AMENDMENT

ETS 300 347-1

A1

**Signalling Protocols and Switching (SPS);
V interfaces at the digital Local Exchange (LE);
V5.2 interface for support of Access Network (AN);
Part 1: V5.2 interface specification**

Page 206, figure L.18.2

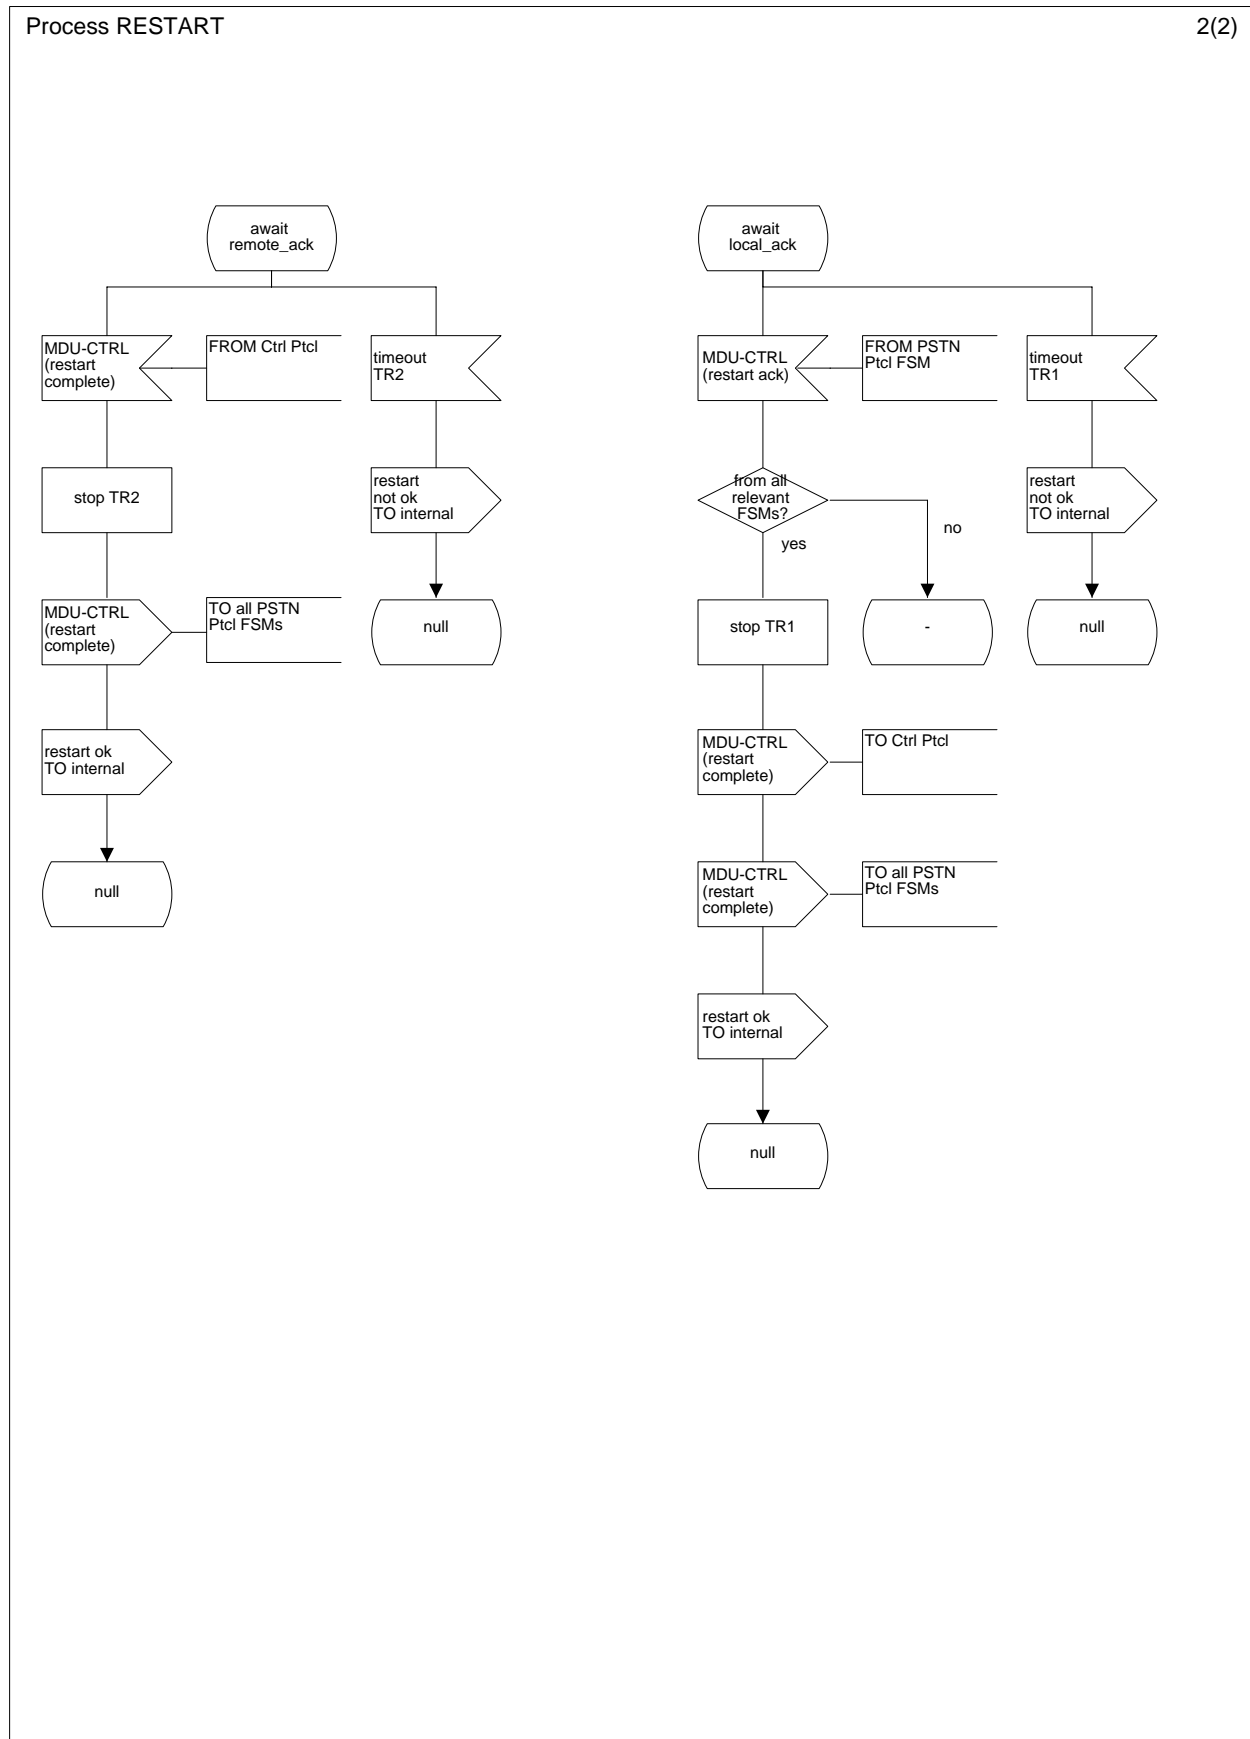
Replace the complete figure.

Figure L.23a.1: Accelerated port alignment procedures AN-side (sheet 1 of 3)

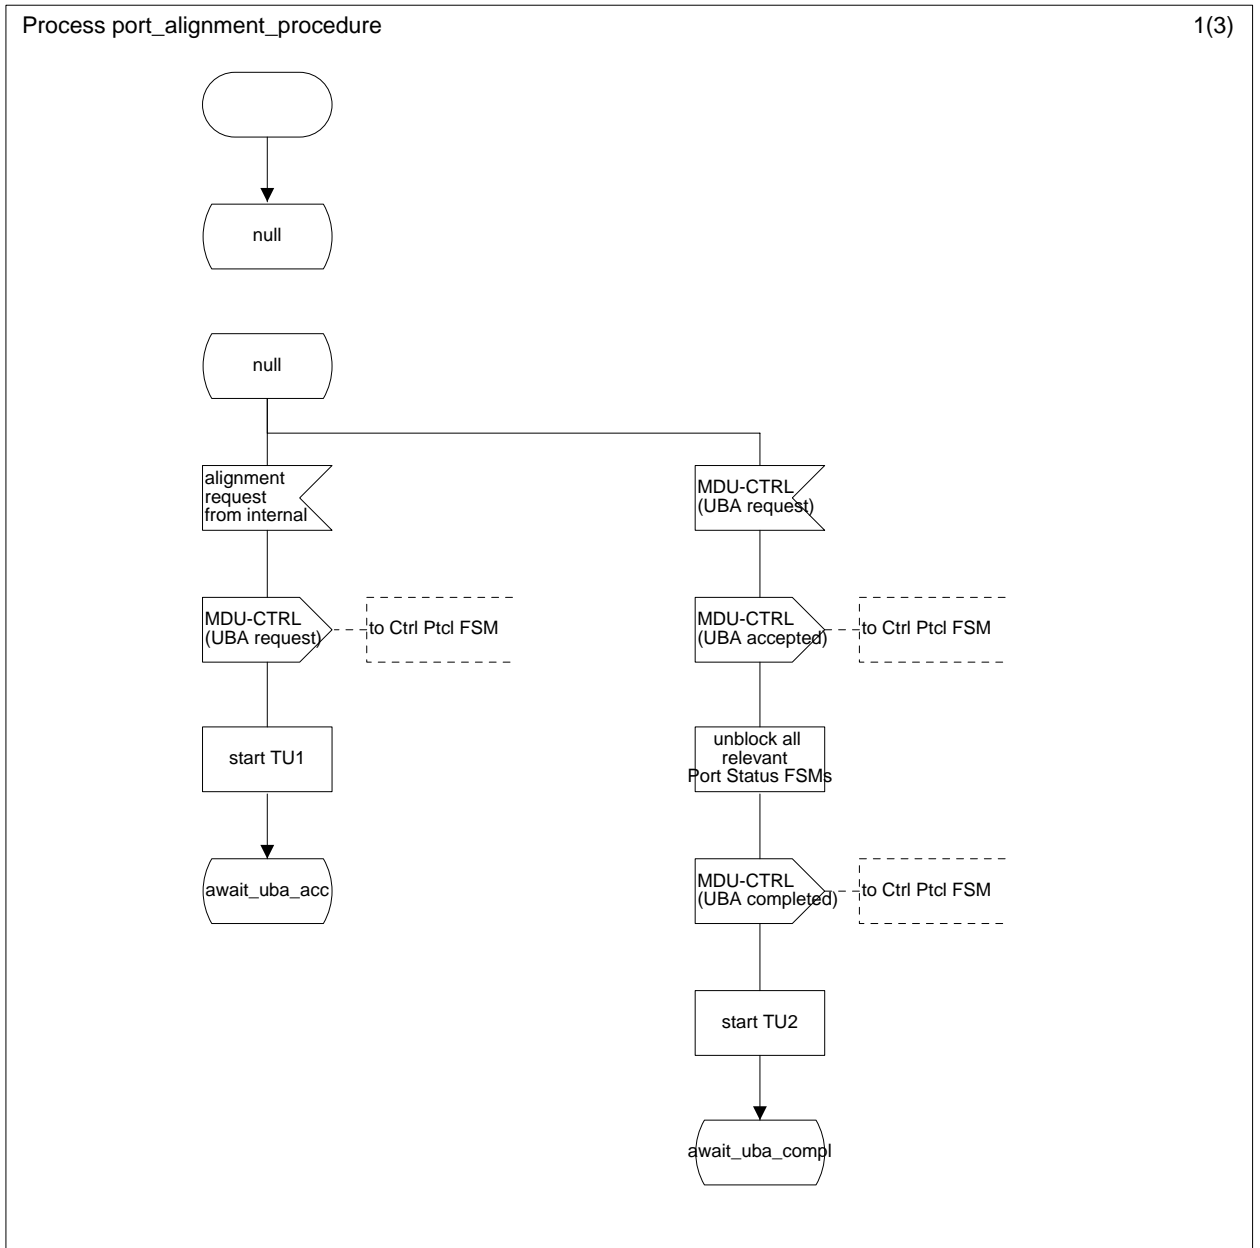
Insert a new subclause L.1.8.7 after figure L.23.3

L.1.8.7 Accelerated port alignment procedure

Page 220, figure L.29

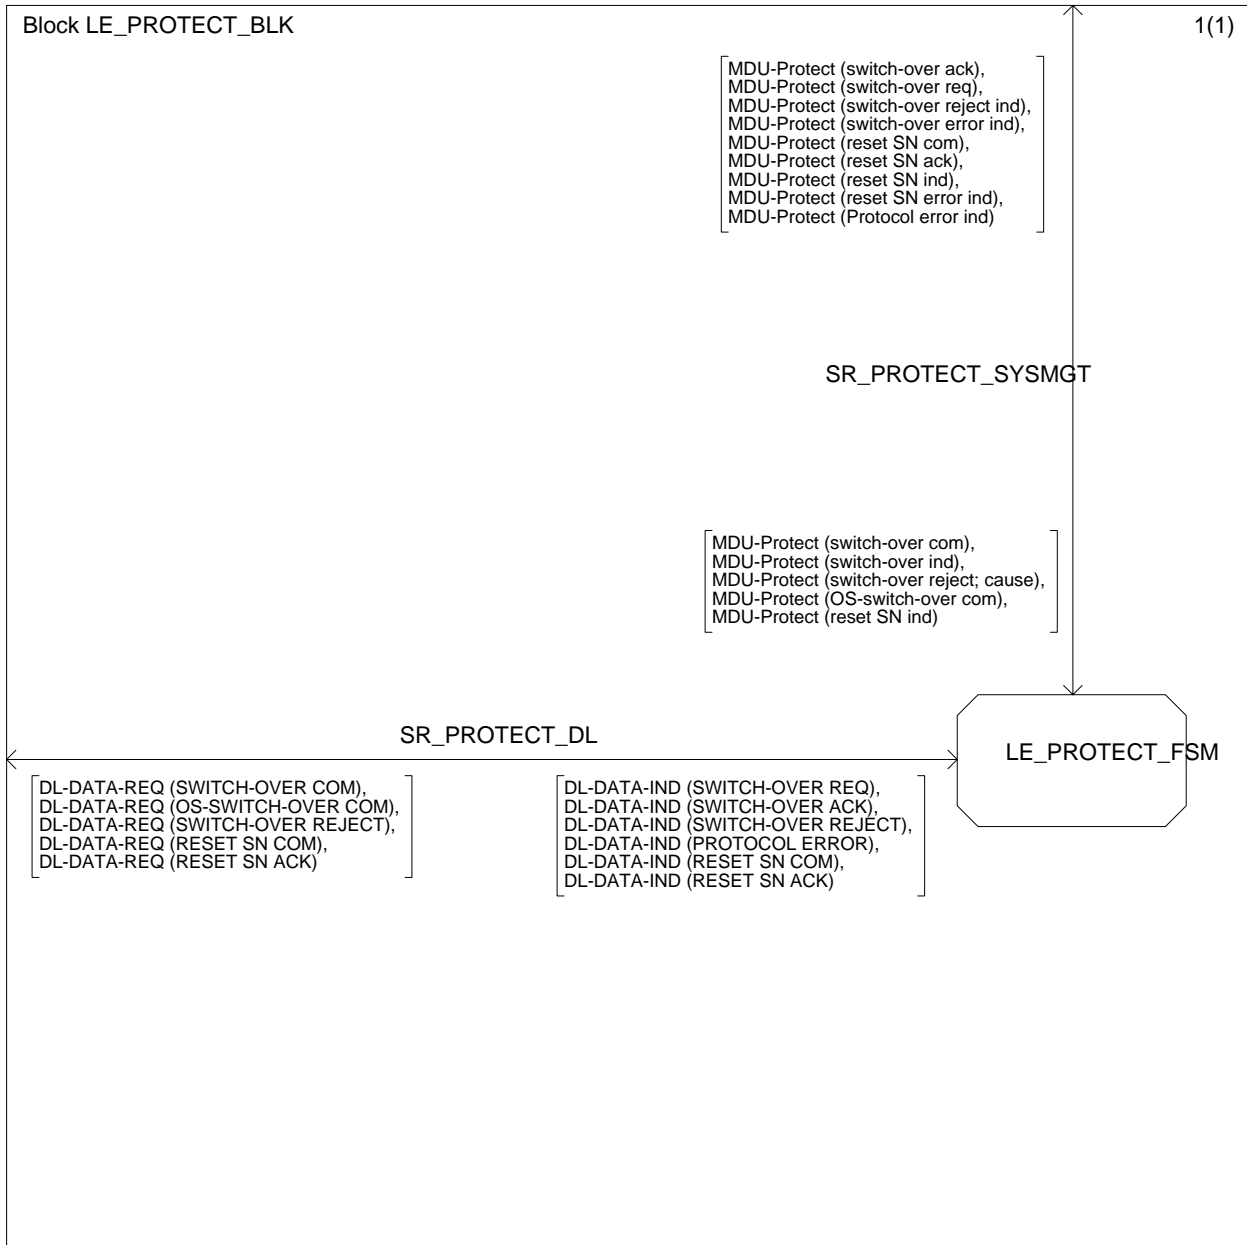
- Annex L, figure L.29: Some MDU-Protection primitives are missing for SR_PROTECT_SYSMGT: reset SN com, reset SN ind, reset SN ack, reset SN req and Protocol error indication.

Replace "switch-over req ind" by "switch-over req" for signal route SR_PROTECT_SYSMGT, upper signal list.

Add the following MDU-Protection primitives for signal route SR_PROTECT_SYSMGT, upper signal list: reset SN ind, reset SN com, reset SN ack, reset SN error ind and Protocol error ind.

Add the following MDU-Protection primitives for signal route SR_PROTECT_SYSMGT, bottom signal list: switch-over com, OS-switch-over com and reset SN req.

Delete the following MDU-Protection primitives for signal route SR_PROTECT_SYSMGT, bottom signal list: switch-over req.

Page 229, figure L.33.2, state "IN SERVICE"

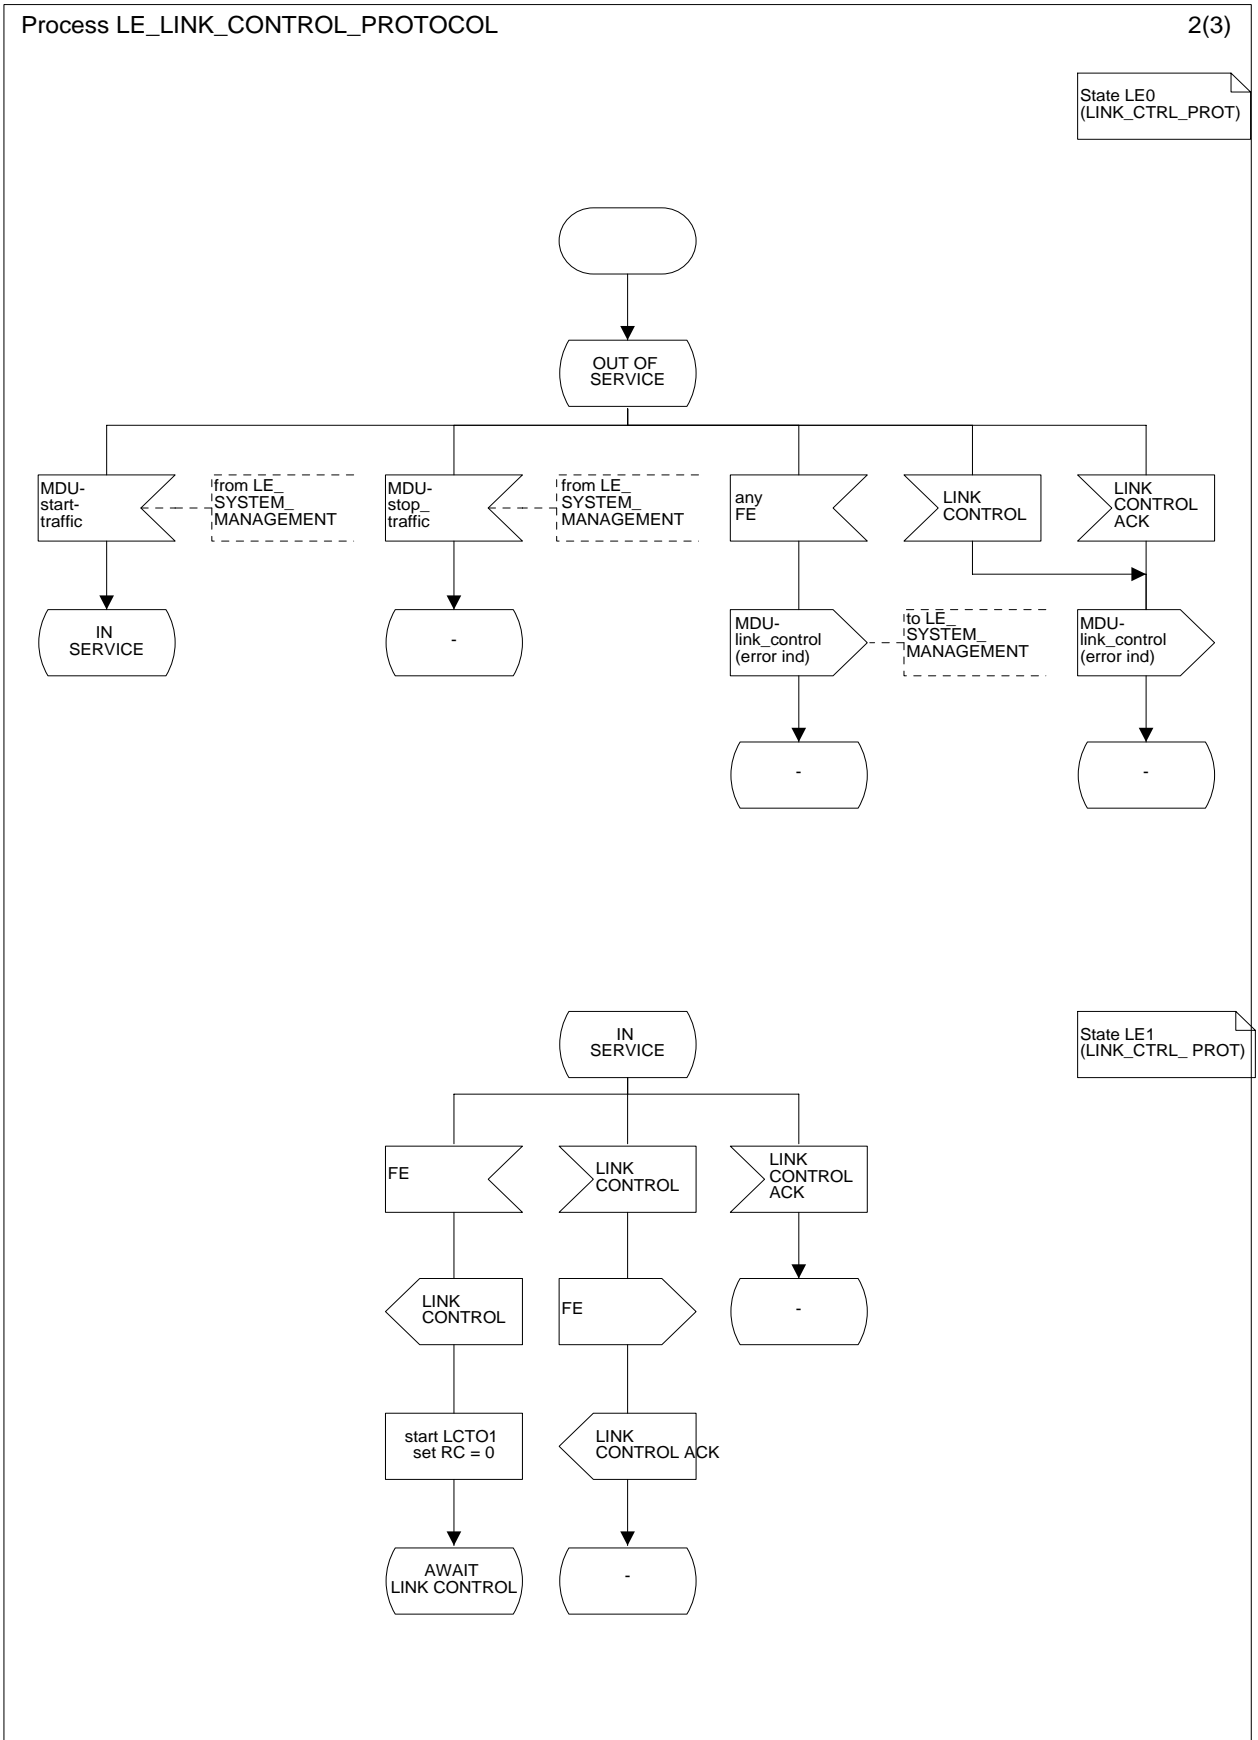
- Annex L, figure L.33.2: In the bottom diagram, the symbol for the message LINK CONTROL ACK has the wrong direction.
- Annex L, figure L.36.4: The cause for start of timer TSO4 is misalignment of sequence numbers VP(S) or VP(R) and repetition at the first timeout. Initialization of the sequence numbers V(P) or V(P) is only done in the procedure for misaligned handling according to figure L.14. This procedure is applied at the AN side and LE side.
When a misalignment is detected and TSO4 is running, there will be no further protocol messages apart from RESET SN COM. Therefore, the sequence numbers remain in their initialization values.
Amendment: Both figures L.13.4 and L.36.4 are corrected with a task symbol to initialize VP(S) and V(P) before start of TSO4.

Flip the input symbol "LINK CONTROL ACK".

Page 247, figure L.36.5, bottom left branch

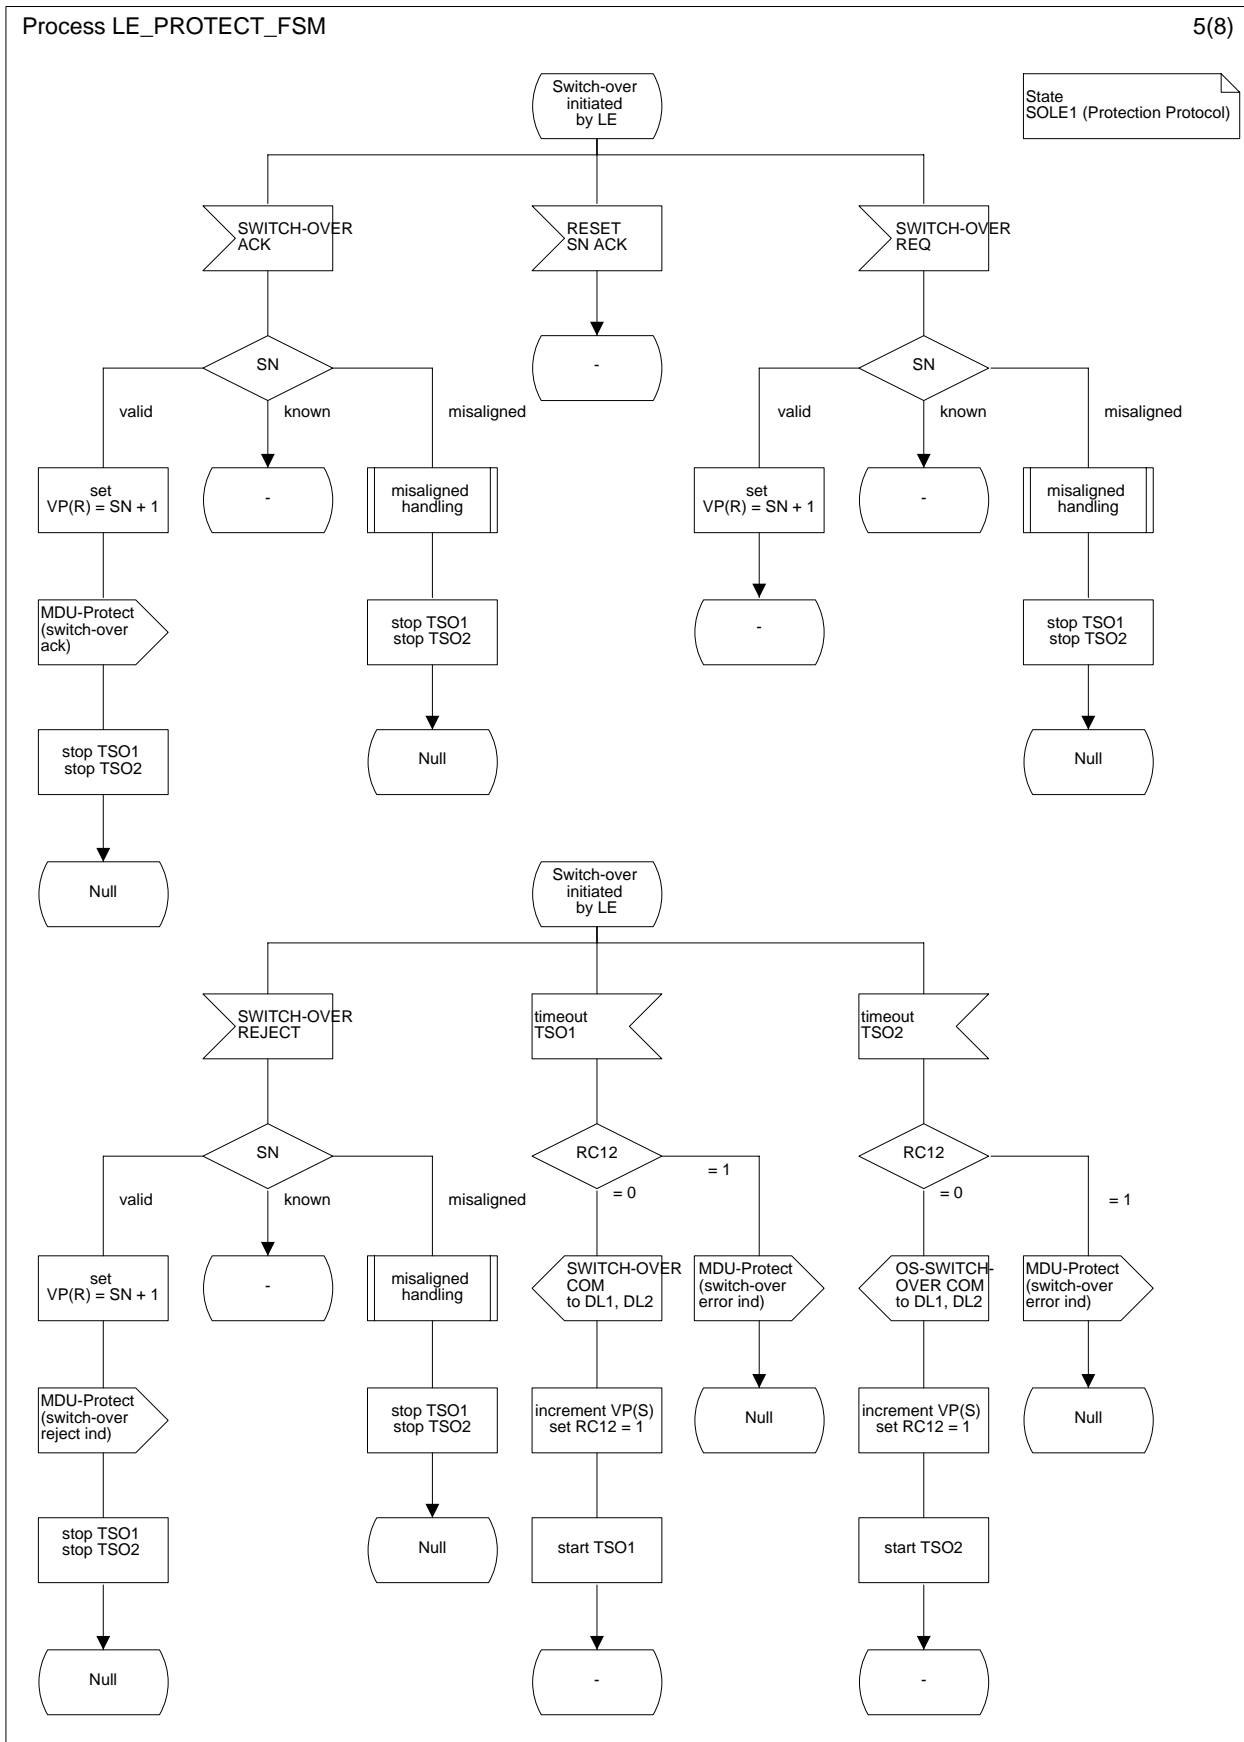
- Annex L, figure L.36.5: A stop of timer TSO2 is missing in the bottom left branch.
- Annex L, figure L.36.7: In the bottom diagram, the symbol for the message RESET SN ACK has the wrong direction.

Insert "stop TSO2" into the task symbol "stop TSO1".
